Re: Wellington North Solar Farm SSD-8895 – Request for Information (RFI) 17-382

NGH have prepared responses to the RFI for Wellington North Solar Farm SSD-8895 on behalf of Wellington North Solar Farm Pty Ltd (“the proponent”), as discussed in consultation with AGL and DPIE. Points have been grouped together where the requests were of a similar theme. Each information request from DPIE is provided in **bold italicised** text, above the proponent’s response.

Surrounding Solar Farms

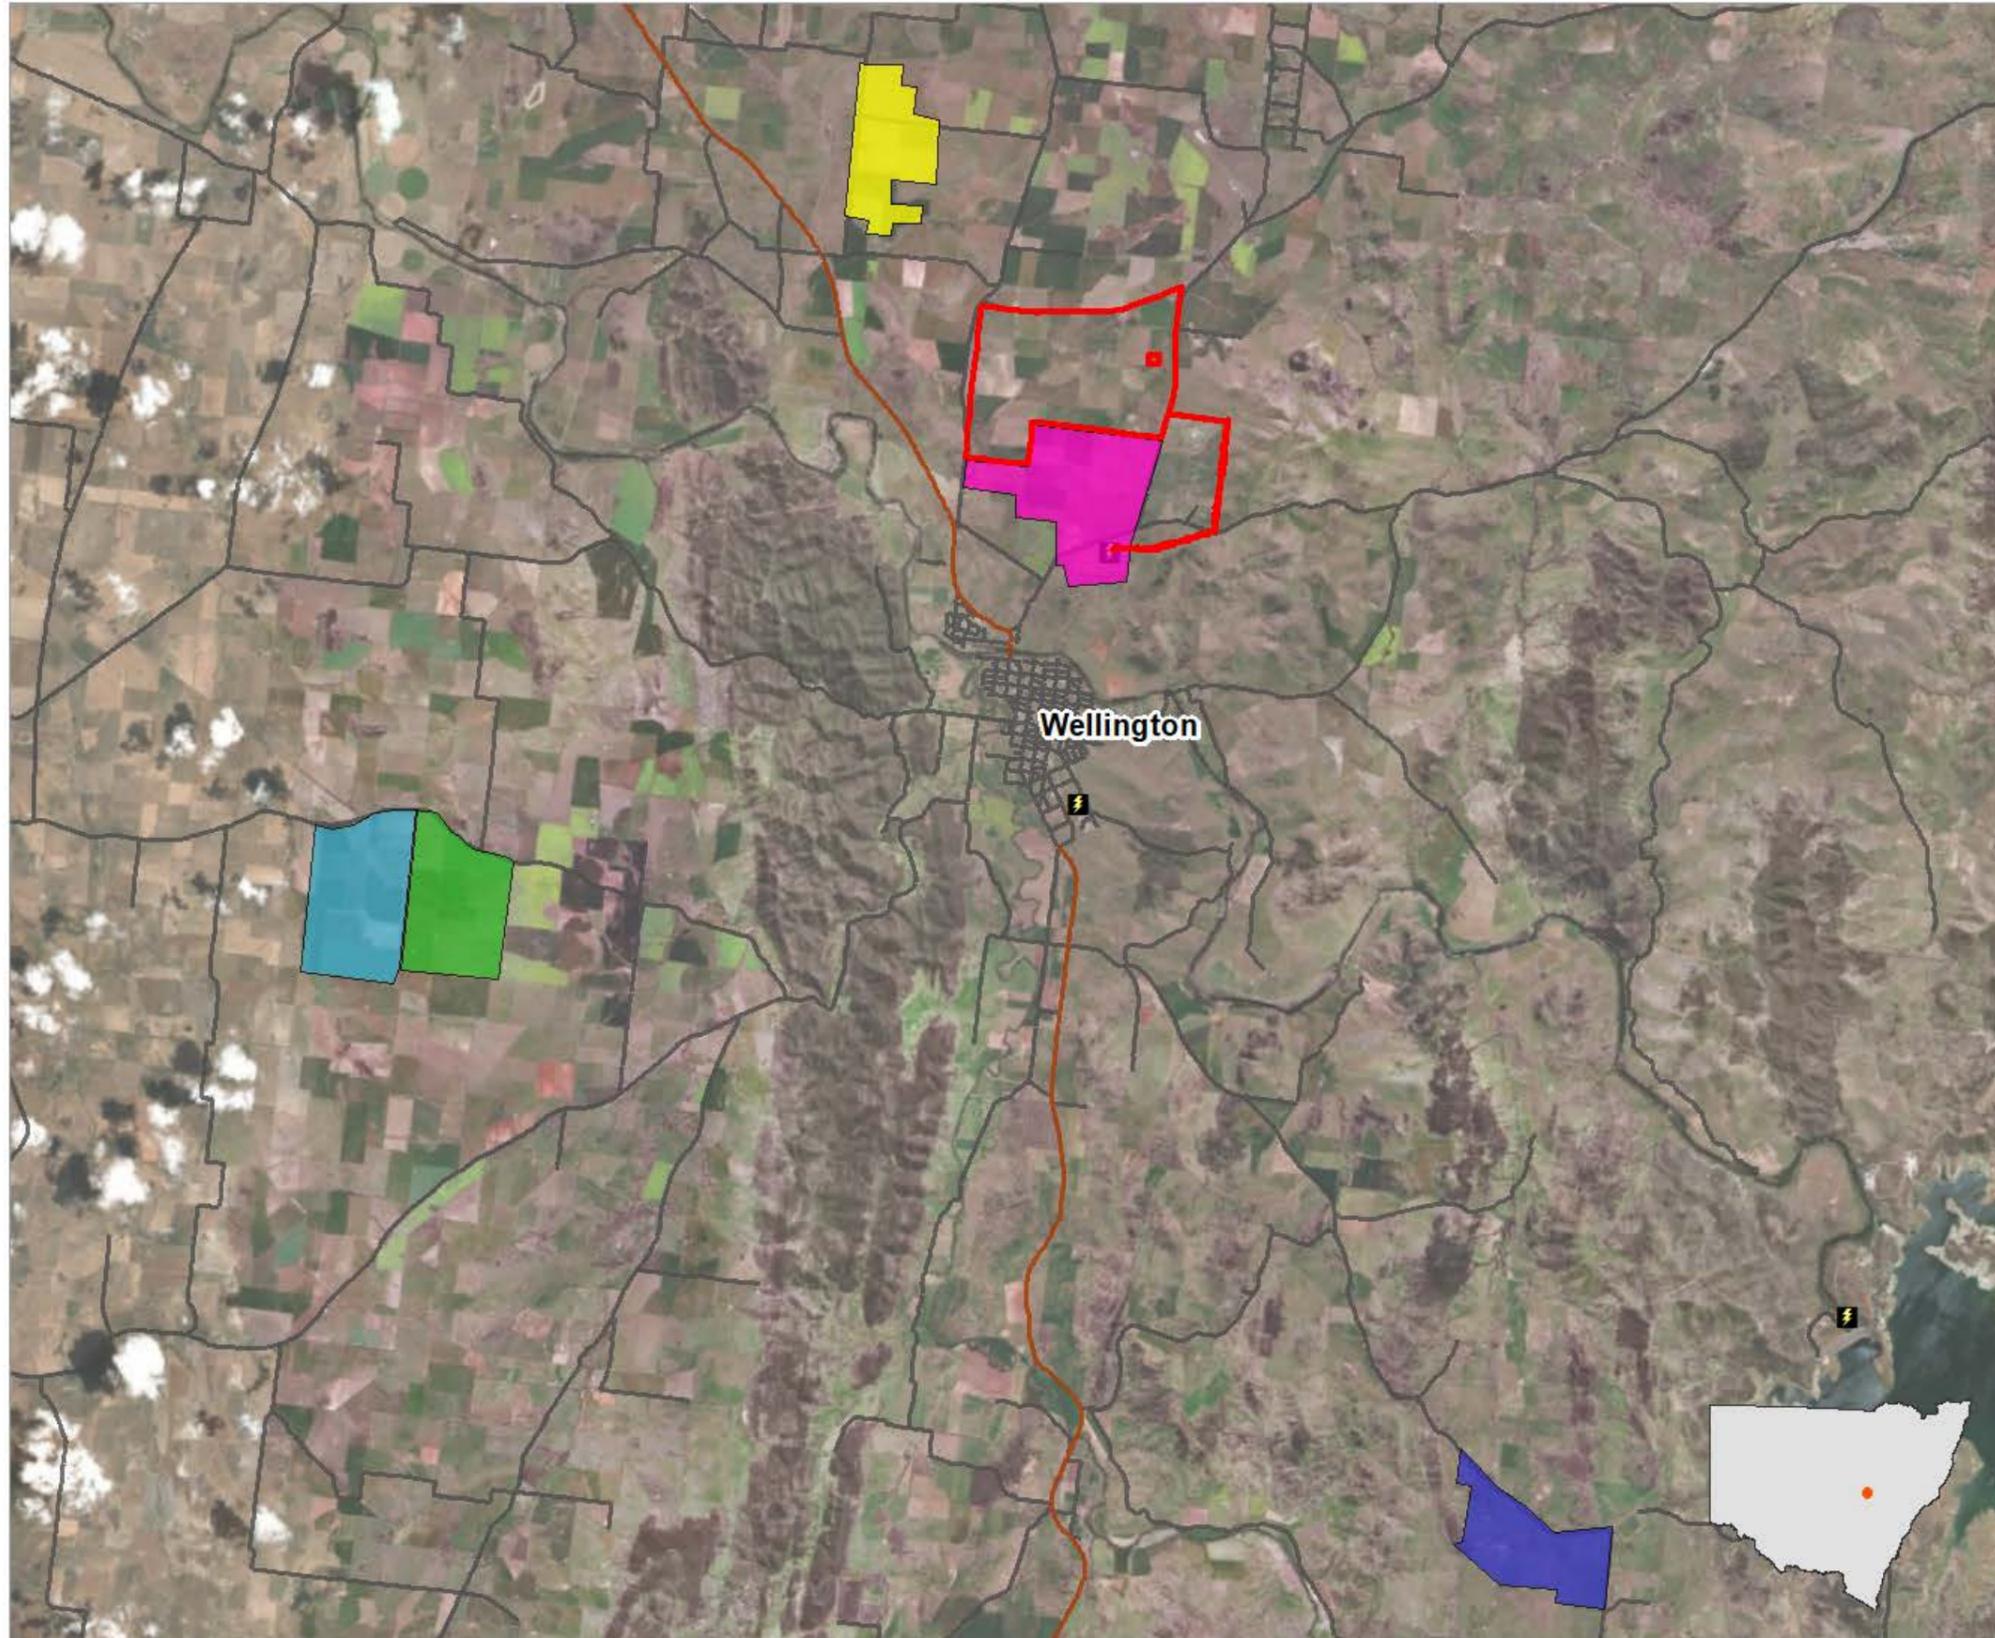
- Adjust scale to approximate area shown in yellow
- Label Wellington town centre on map
- Lighten the base layer of the map, to improve the visibility of the figure.

Updated map below.
